**SUBJECT:** NuScale Power, LLC Response to NRC Request for Additional Information No. 427 (eRAI No. 9408) on the NuScale Design Certification Application

## **Response to Request for Additional Information Docket No. 52-048**

**eRAI No.:** 9408

**NRC Question No.:** 03.09.02-76

Figure 2-8 Tube inlet flow restrictor and mounting plate

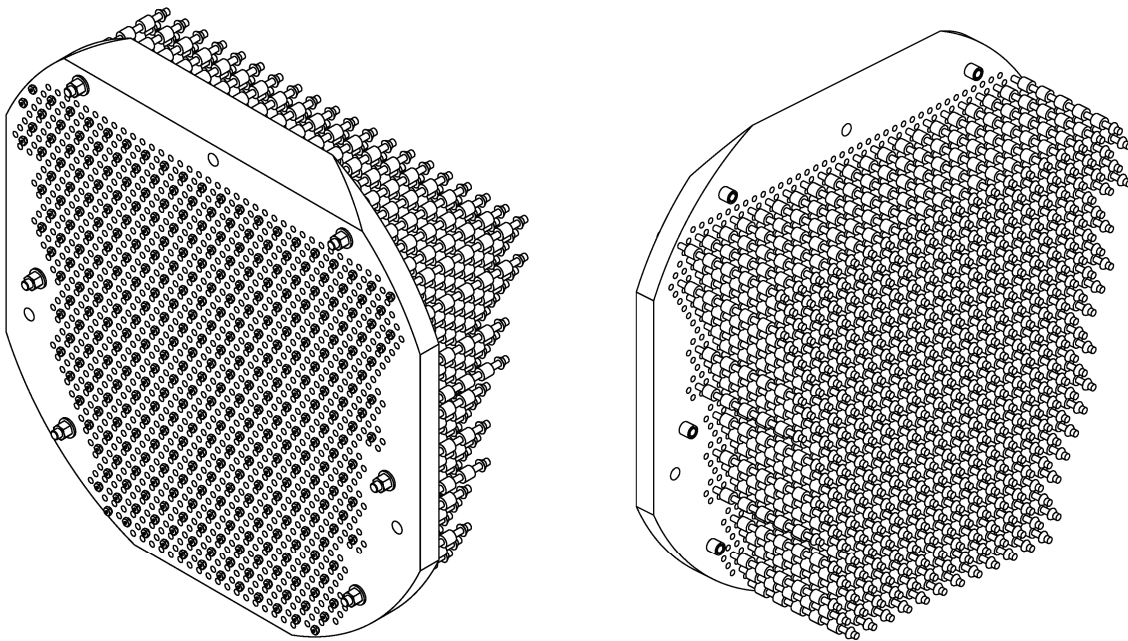
10 CFR 50, Appendix A, GDC 4 requires structures, systems, and components important to safety shall be designed to accommodate the effects of and to be compatible with the environmental conditions associated with normal operation, maintenance, testing, and postulated accidents. The only reactor vessel internals (RVI) component evaluated explicitly for leakage flow instability (LFI) is the SG inlet flow restrictor. Other components with potential leakage flow paths include the joint between the upper and lower risers, gaps in and around the CRAGTs, and the gaps between the CRD shaft and ICIGT and the support plate holes. Provide quantitative explanations of how these regions, and any other RVI with potential leakage flow paths, are not susceptible to LFI. Include estimated pressure differences, along with quantitative explanations of how design rules for LFI avoidance (include applicable references) were followed. Provide a summary of the existing test results for the SG inlet flow restrictor, along with the test plan and acceptance criteria for testing of the final SG inlet flow restrictor design. Alternatively, NuScale may propose other options to resolve the staff's concerns.

The one-dimensional annular flow channel methodology was not applied to the SG IFR. The pressure drop along the annular flow channel for this component is  $\{\{ \}^{2(a),(c)} \text{ psi}$  at full power, more than an order of magnitude larger than the maximum pressure difference for the remainder of the narrow flow channels. The annular gap around the SG IFR is  $\{\{ \}^{2(a),(c),ECI} \text{ in.}$ , significantly smaller than the gaps in the other narrow flow channels discussed above. During normal operation, the gap velocity around the SG IFR is  $\{\{ \}^{2(a),(c)}$  which far exceeds the other gap velocities. Accordingly, benchmarking and a separate effects test are performed to validate that LFI is not a concern for the SG IFR. The NuScale Comprehensive Vibration Assessment Program Measurement and Inspection Plan Technical Report, TR-0918-60894, Revision 0, submitted by NuScale letter LO-1218-63700, dated December 7, 2018, summarizes the plan for validation testing of the SG IFR final design in Section 5.3. Section 3.1 of TR-0918-60894 provides a summary of the existing test results for the SG IFR. The SG IFR is also included in the CVAP inspection program (see Section 7.0 of TR-0918-60894, Revision 0).

Each individual SG tube requires an inlet flow restriction device for the purpose of flow stability. Figure 2-8 provides a representation of the flow restrictor concept. The flow restrictor fits into the tube inlet and is designed to provide flow stability by restricting the volume of the secondary-side flow through the tube. The flow restriction is created by a series of narrow annular gaps between the restrictor and the tube inner diameter. To hold the flow restrictors in position, mounting hardware (plate) is required within the feed plenum. The plate is removable and held in place with fasteners. The flow restrictors are attached to this mounting plate. The flow restrictors and mounting hardware are anchored at a series of points with individual fasteners rather than with extended seams (e.g., welds). Based on the narrow annular gaps between the SG tube and the flow restrictor and the relatively large pressure loss in this region ([Table 2-4](#)), the flow restrictor is susceptible to leakage flow induced vibration. The mounting plate is stiffer than the flow restrictor and provides larger flow area. Therefore, leakage flow induced vibration is not a concern for the mounting plate. Similarly, the turbulent buffeting vibrations of the flow restrictor will bound those of the mounting plate due to the increased stiffness and reduced convective velocity of the mounting plate compared to the flow restrictor.
